Hallsville School District

All Purpose Field & Parking Lot Primary School Classroom Addition Secure Entry Doors

Progress Report #1

SUPPLEMENTAL INSTRUCTION 1 (SI 1)

SHEET
C201

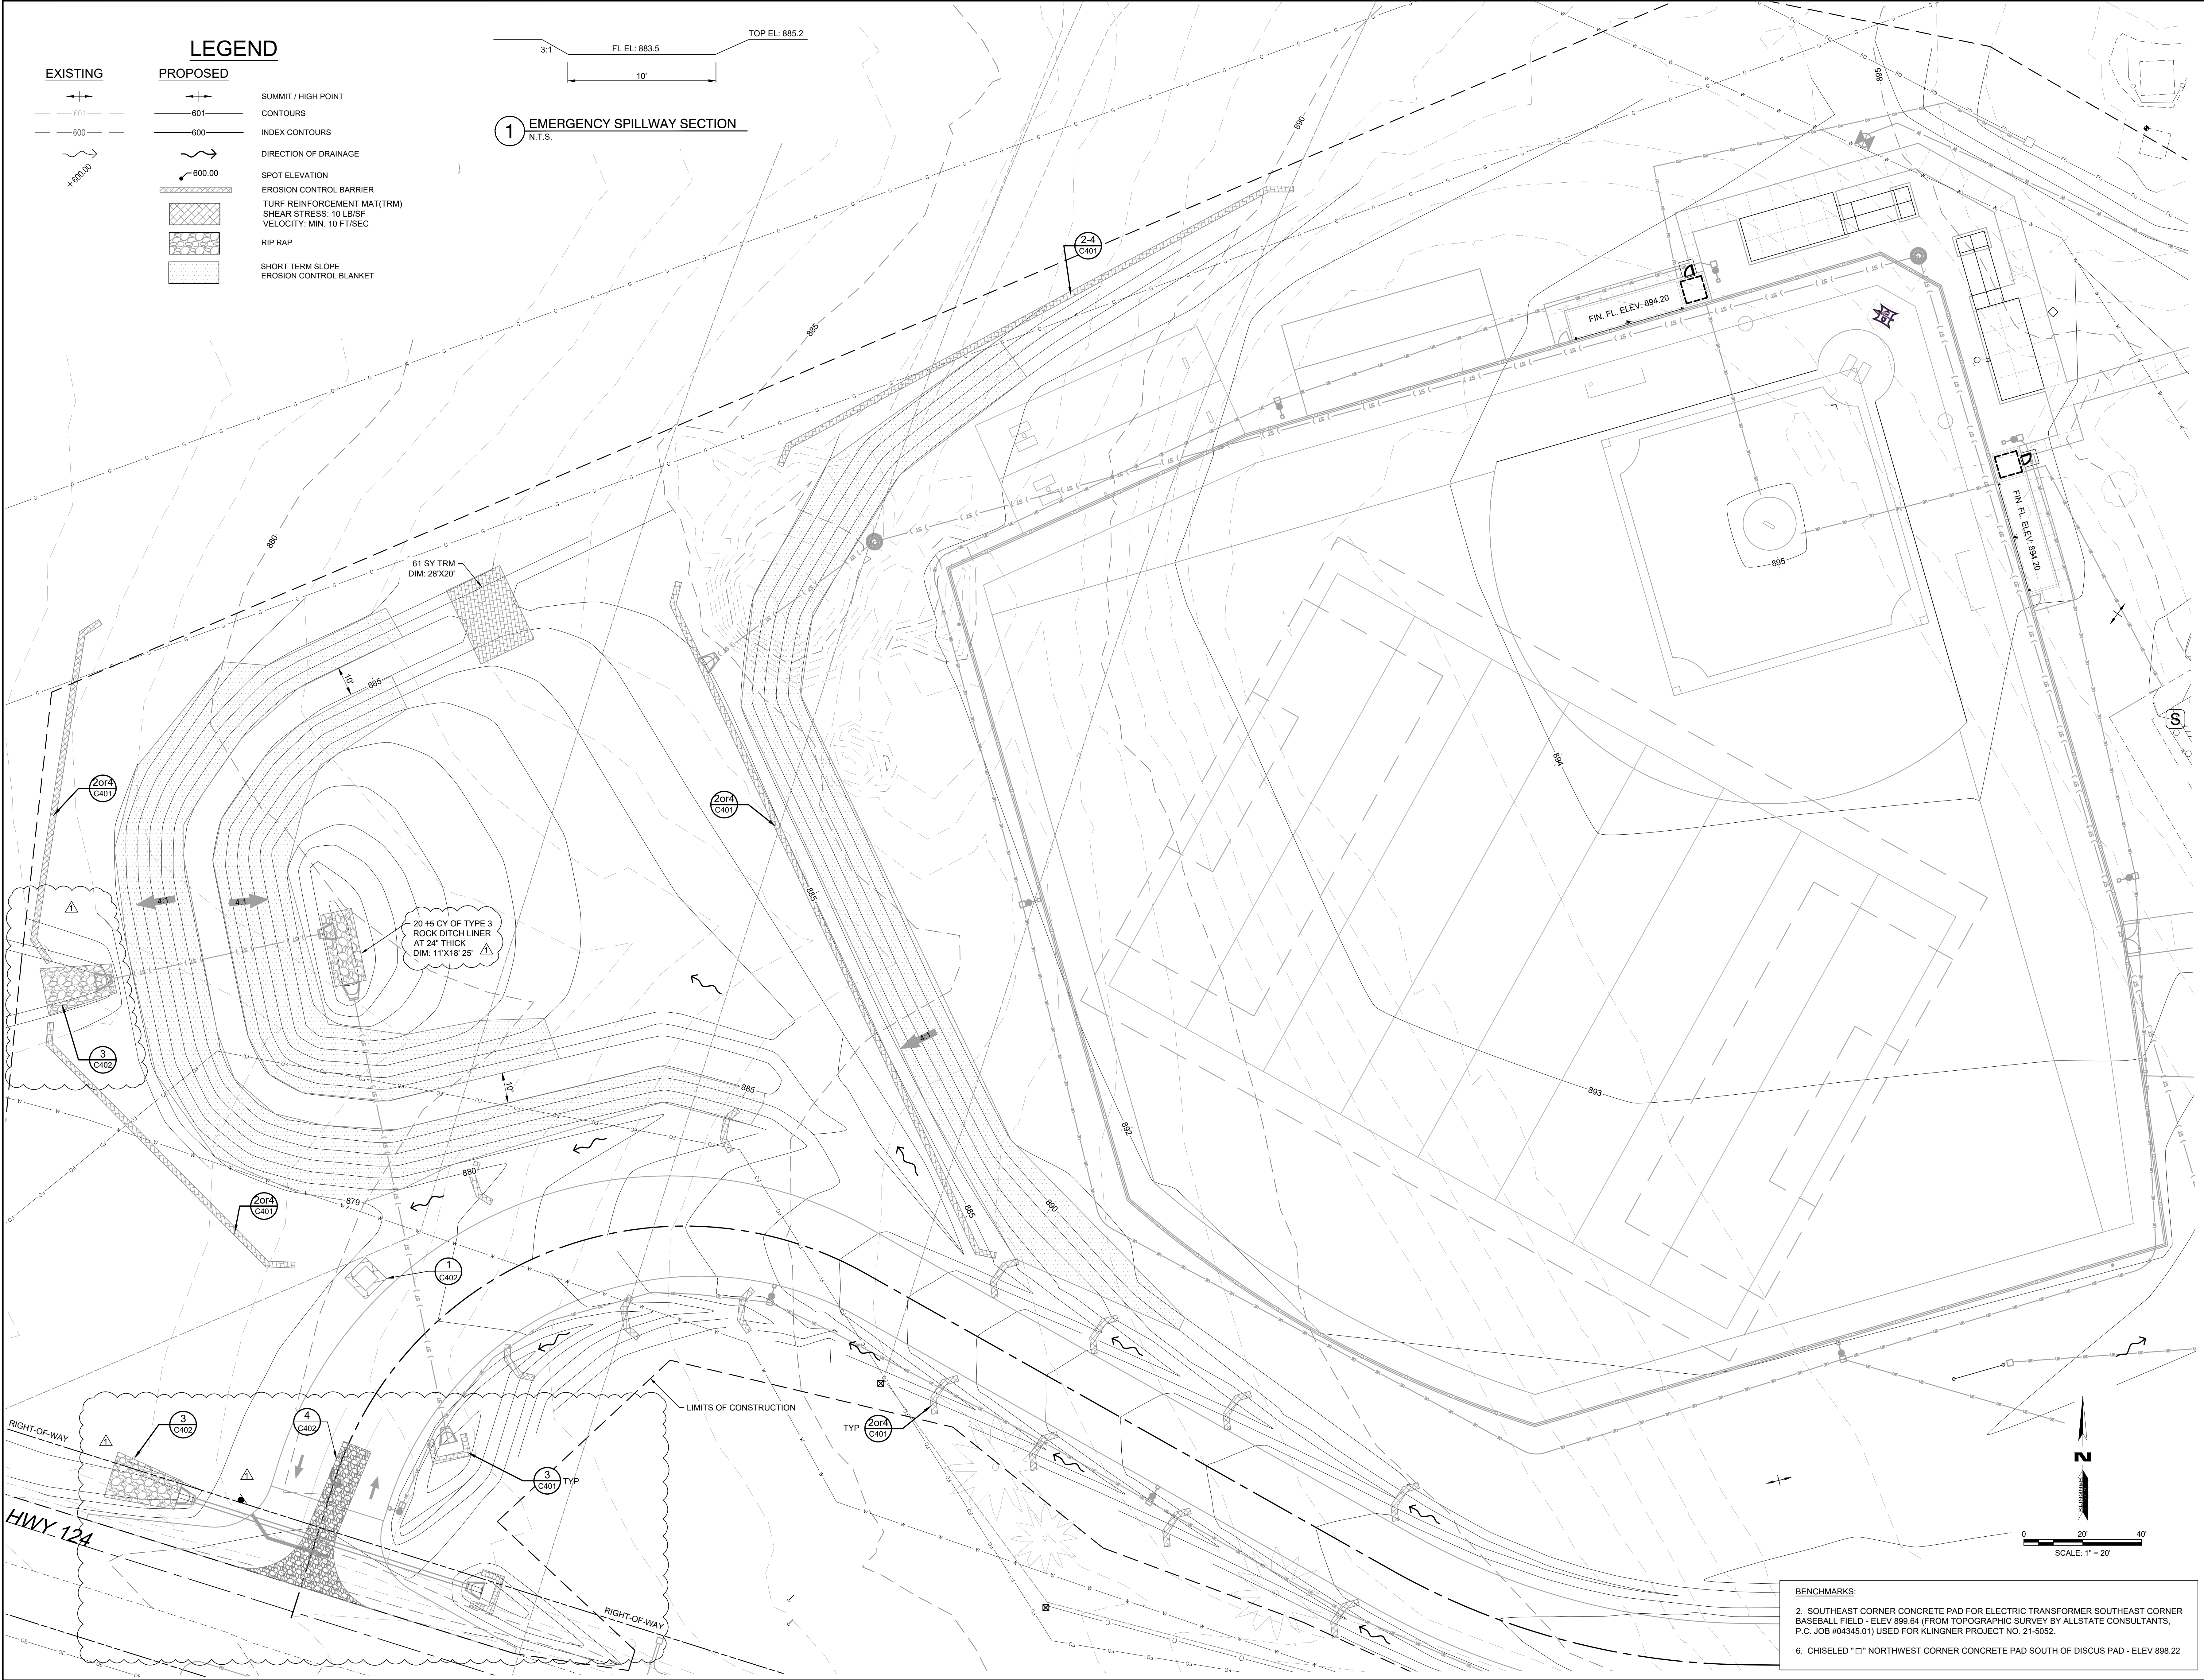
| 4 | Sheet C201 | Moved entrance culvert to be completely within the right-of-way. Adjust grades accordingly. |

ENLARGED GRADING & EROSION CONTROL PLAN - WEST
PROJECT NO: 24-5017
DRAWING ISSUED DATE: 11/14/2025
SHEET
C202

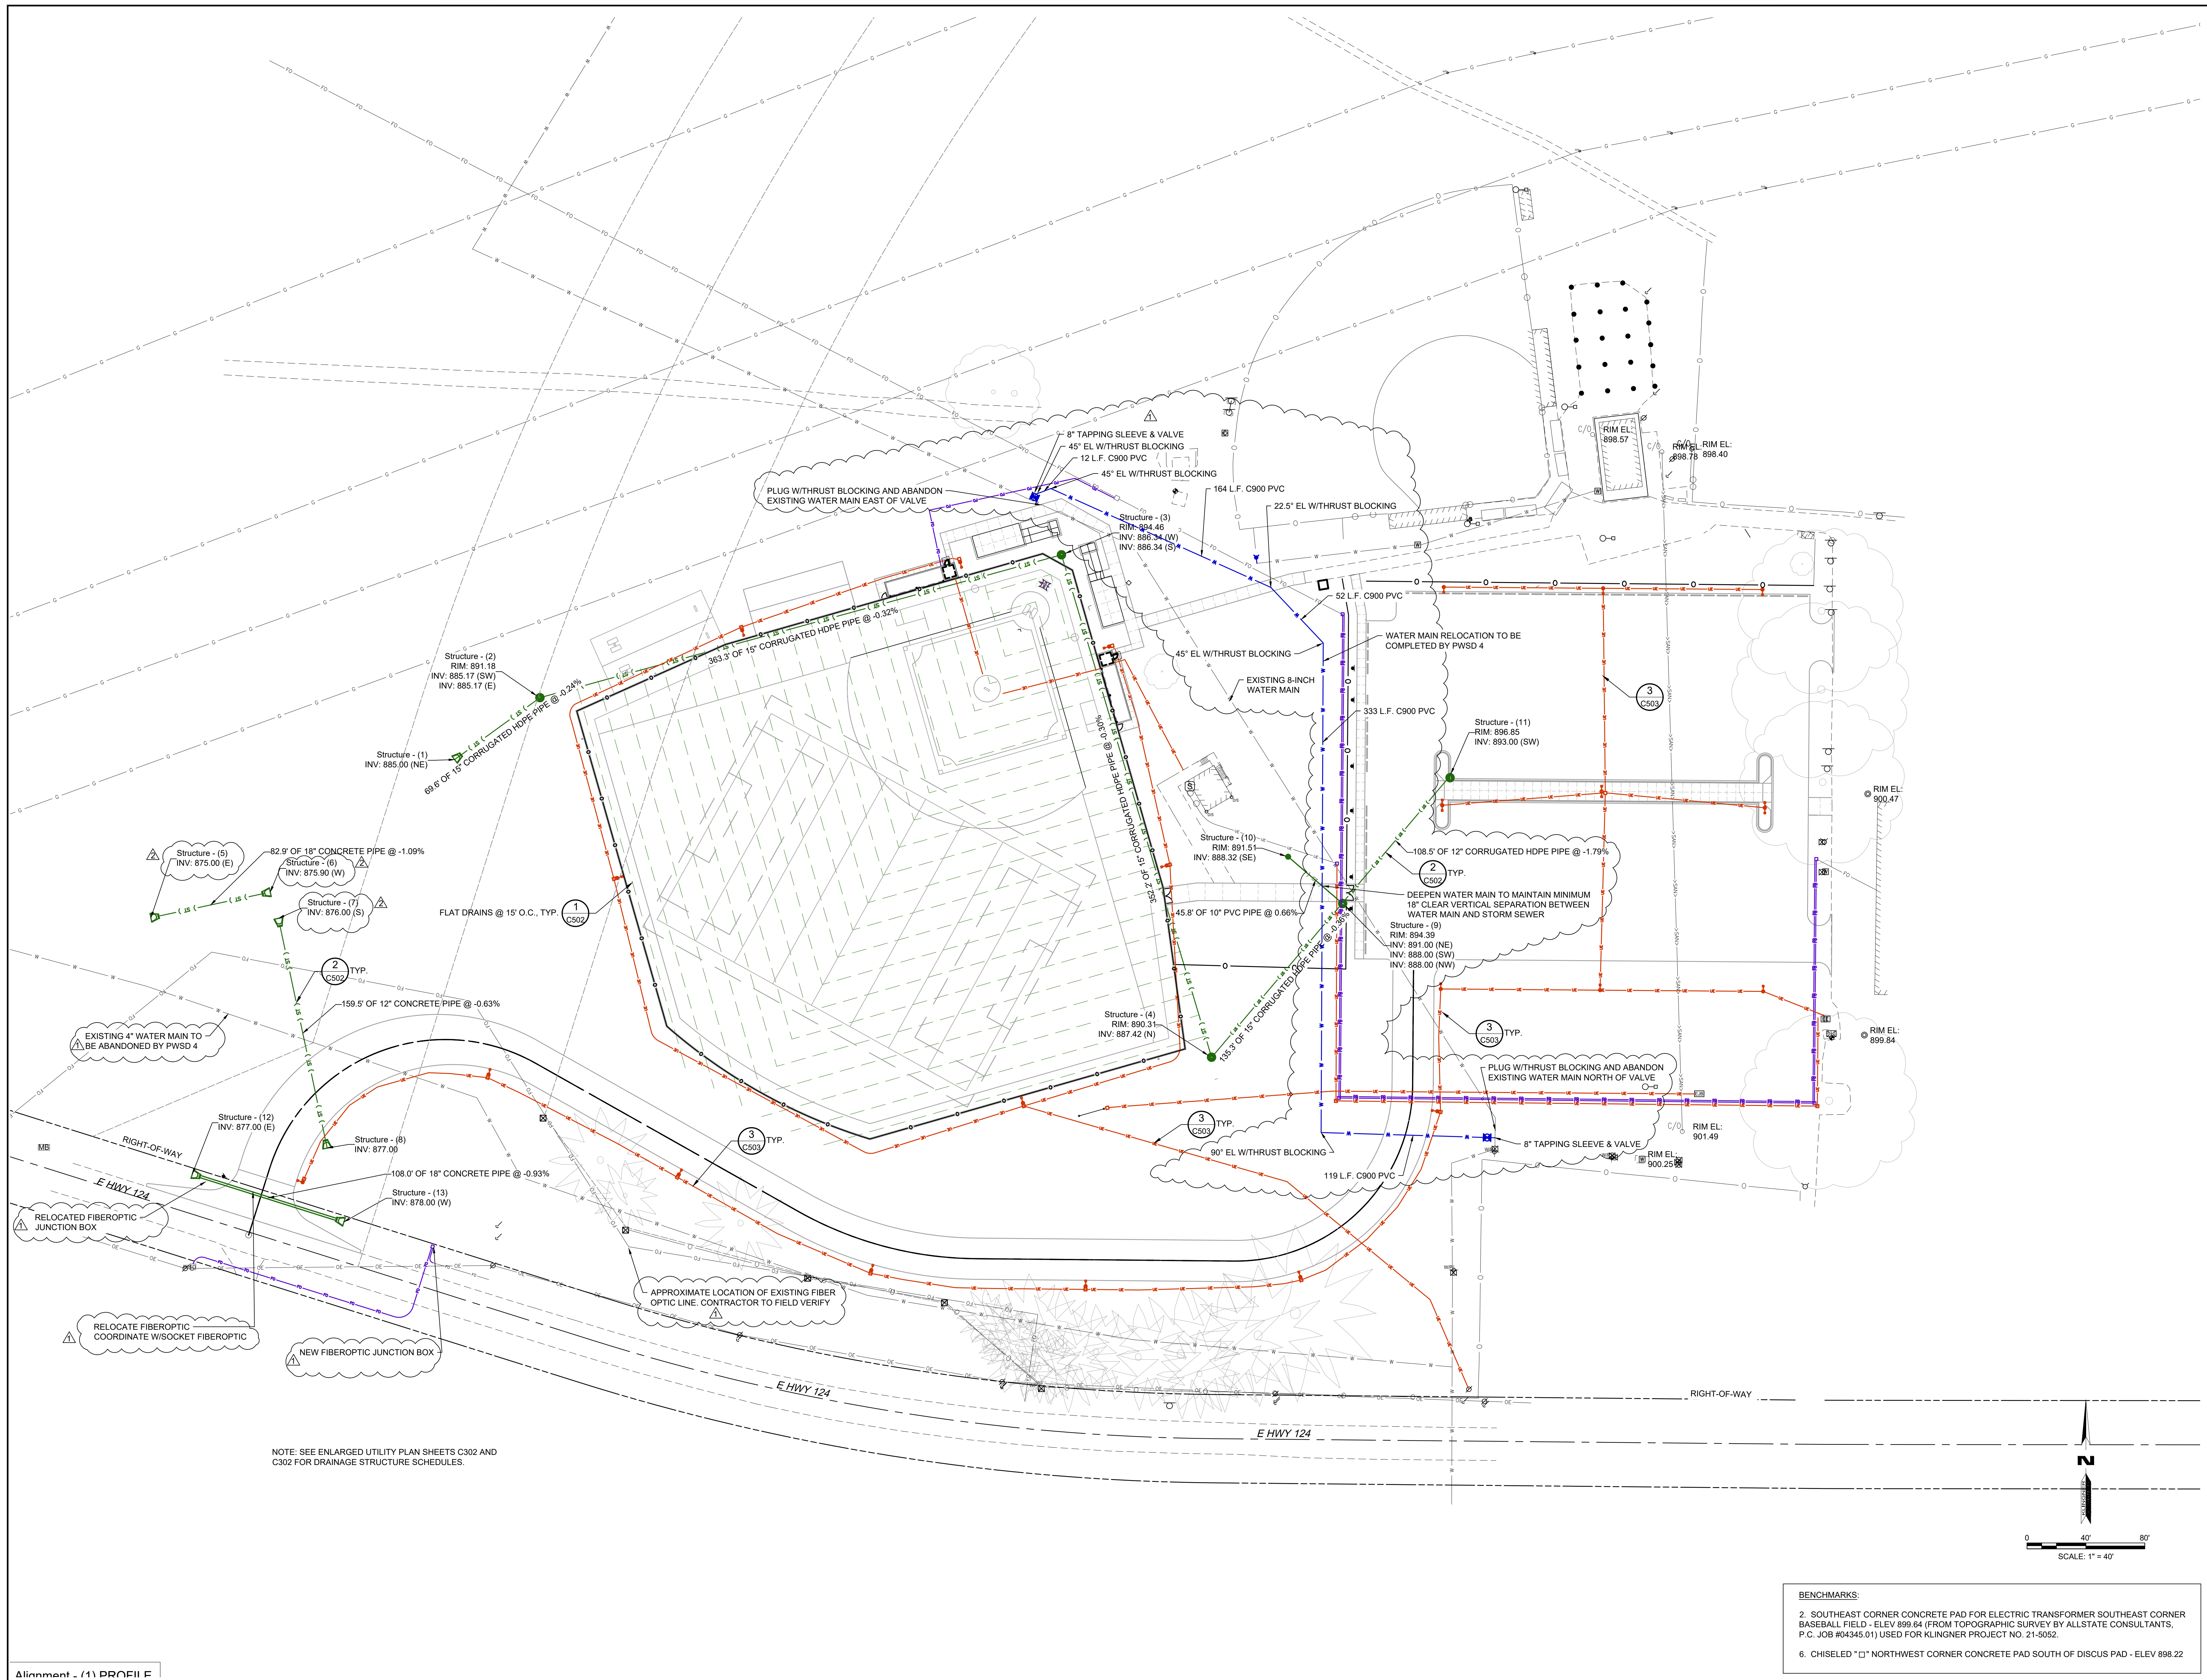
Per the SI 001 revised drawings from Feb 6th, the culvert and grading at the drive entrance shifted to avoid the Right-of-Way, and riprap was added to the West detention basin.

| 5 | Sheet C202 | Moved entrance culvert to be completely within the right-of-way. Adjust grades accordingly. Add riprap in detention basin. |

| NO. | DATE | DESCRIPTION |
|-----|------------|------------------------------------|
| 1 | 11/14/2025 | MOVE ENTRANCE PIPE & ADJUST GRADES |

PROJECT NO. 21-5017
 DRAWING ISSUED DATE: 11/14/2025
 SHEET
C301

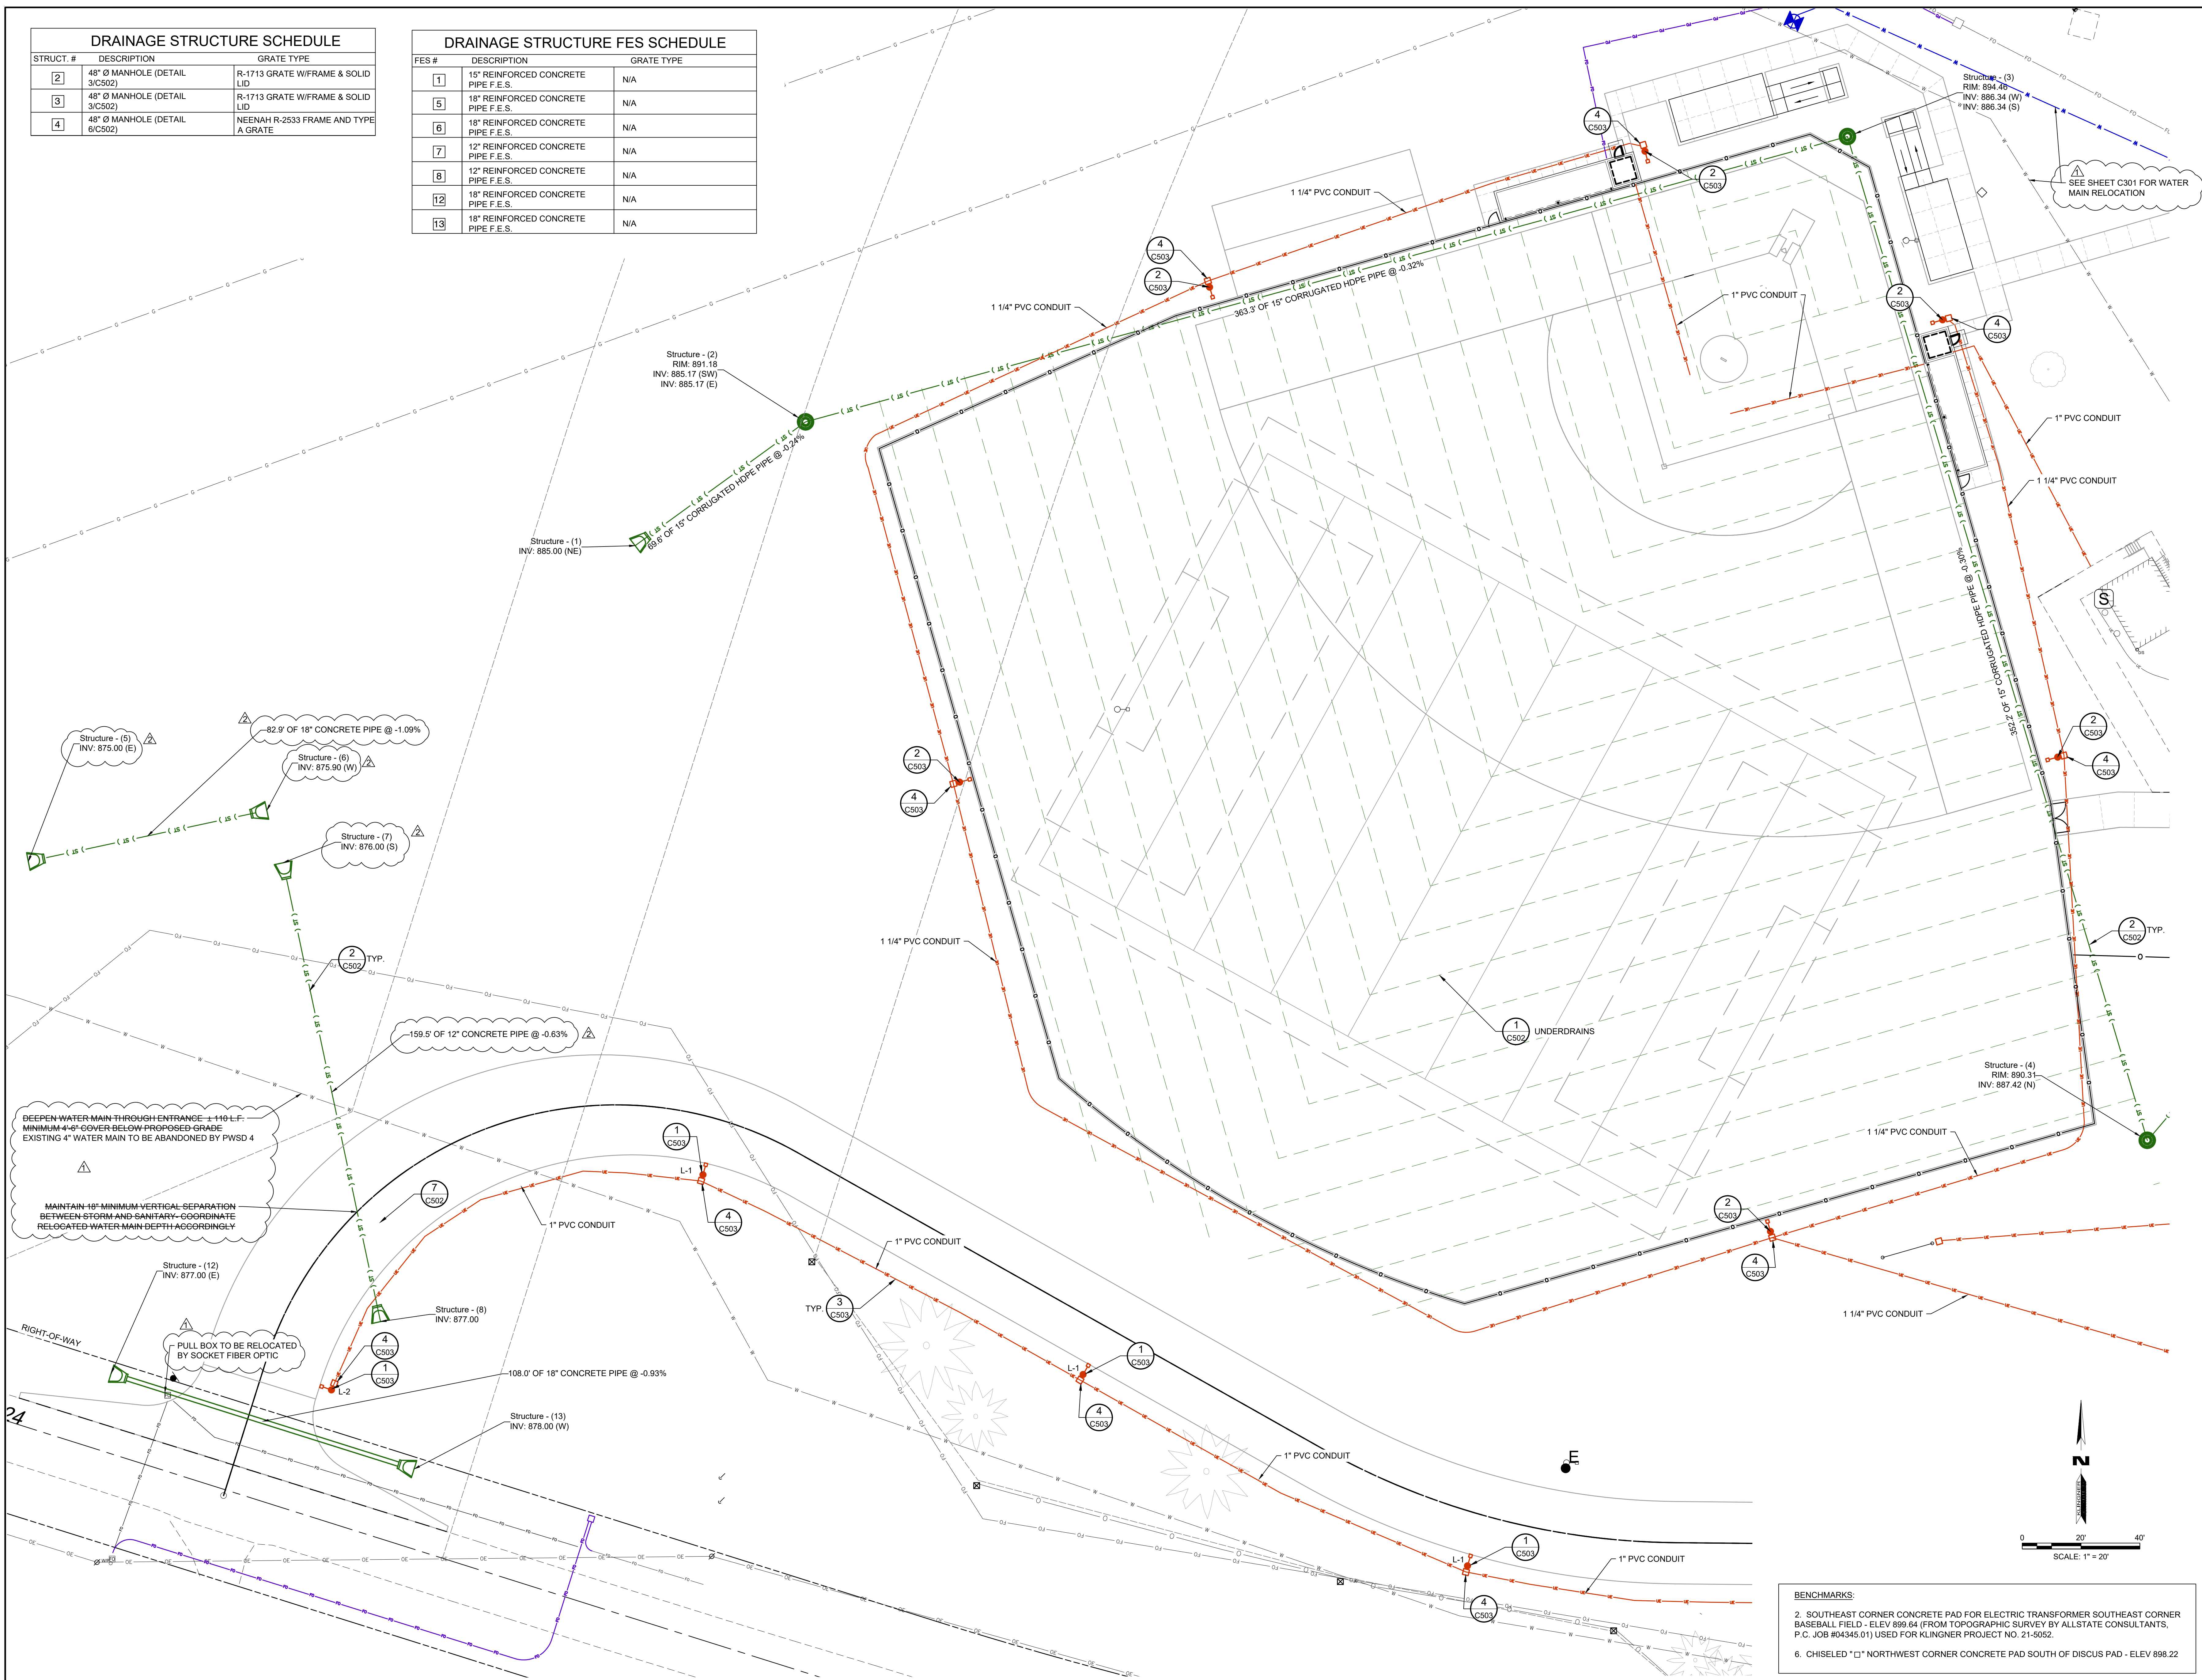
| 6 | Sheet C301 | Revise pipe flowlines. |

| NO. | DESCRIPTION | DATE | BY |
|-----|--------------------------------|----------|-----|
| 2 | REVISE GRADES & PIPE FLOWLINES | 10/12/25 | DCS |
